Technical Advisory Bulletin (TAB)

Bulletin #: TBBEE1616A

Product: BERNINA E16

Subject: New Color Change Motor Encoder

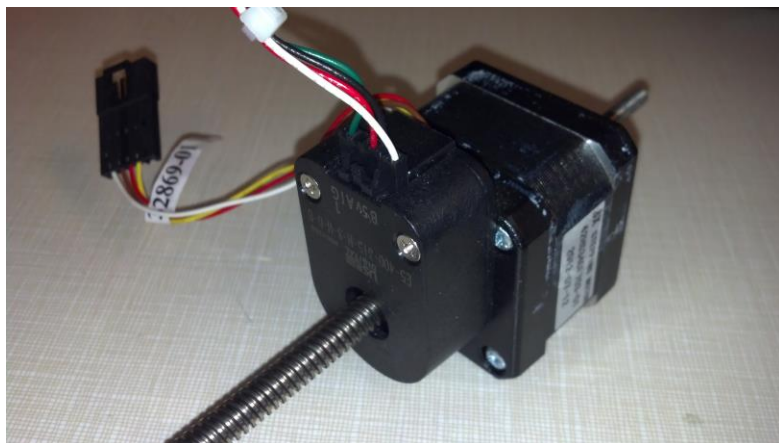
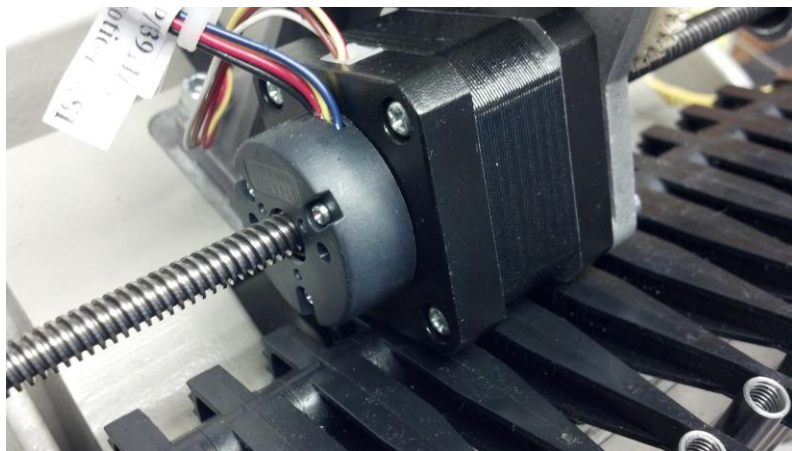
The current Color Change Motor, PN 32987 or 33911, was changed to incorporate a new encoder (new CC Motor PN is 32987-01). The current and new encoders are shown in the pictures below:

Current Encoder with 31290-02 Encoder Harness

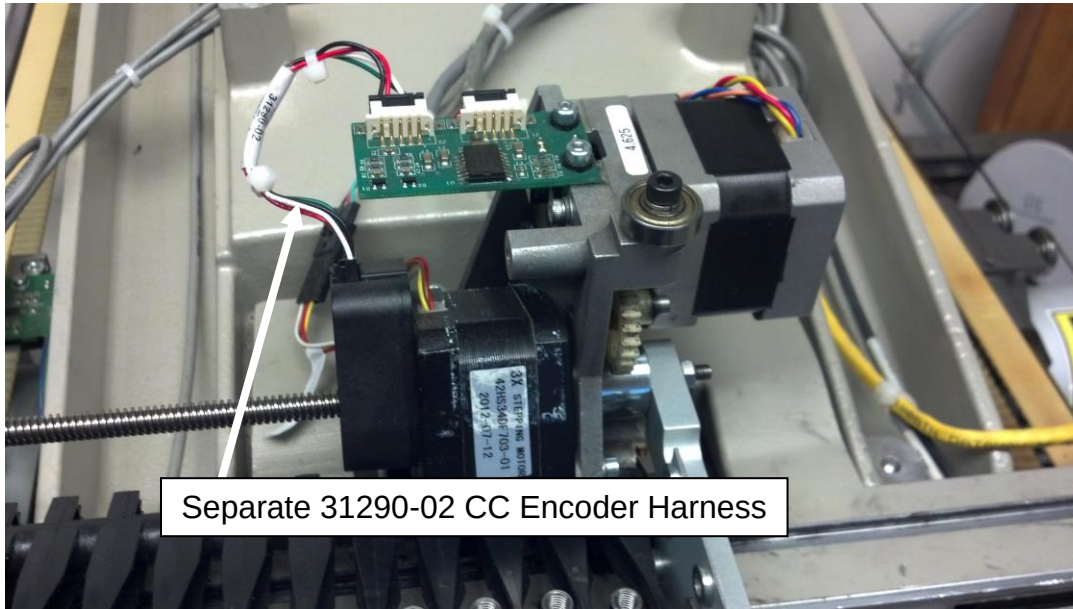
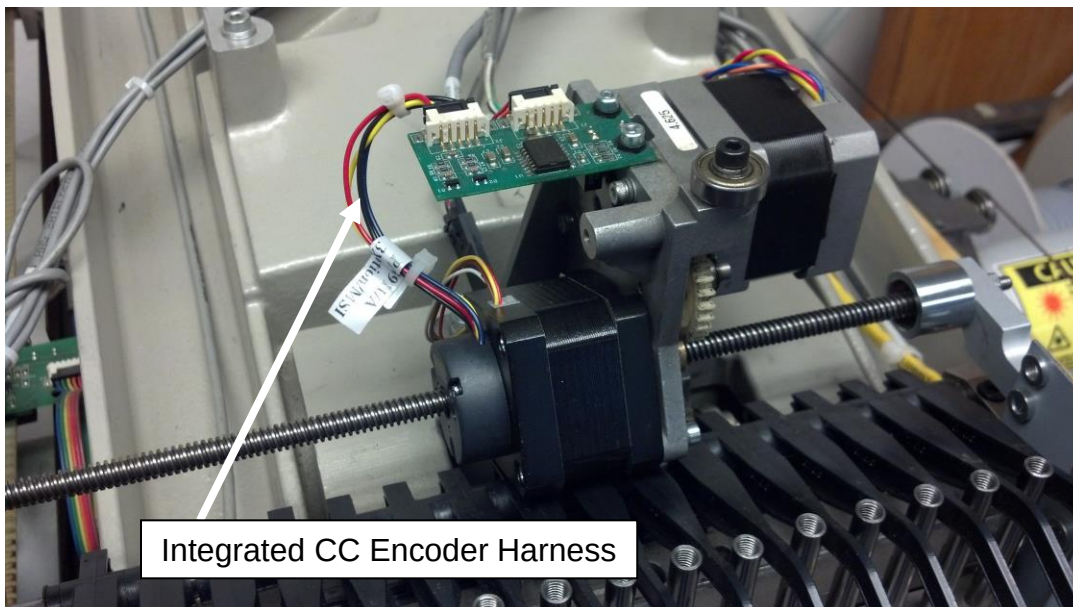
The **new Color Change Motor (PN 32987-01)** is downward compatible with one minor difference. When replacing an **old Color Change Motor (PN 32987 or 33911)** in the field, the separate 31290-02 CC Encoder Harness is no longer required since it is now integrated into the new encoder. See before and after pictures below.

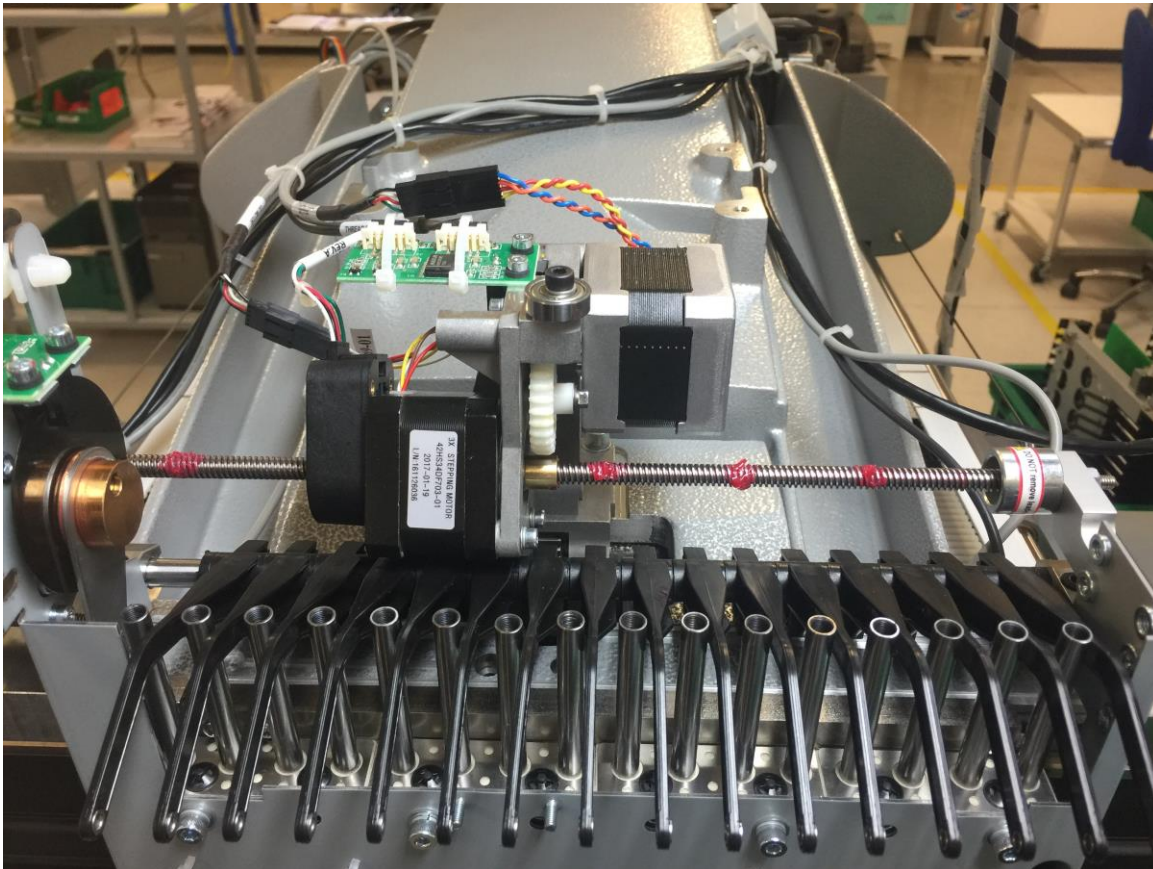
After installation of the CC Motor, apply 4 dabs of High Performance Grease (PN 34463) equally spaced on the shaft, 5-10 threads wide as shown below.

CAUTION: Applying too much grease will contaminate the motor encoder. Take care to wipe away any excess grease after full Color Change Motor travel (needle 1 through needle 16 and back).
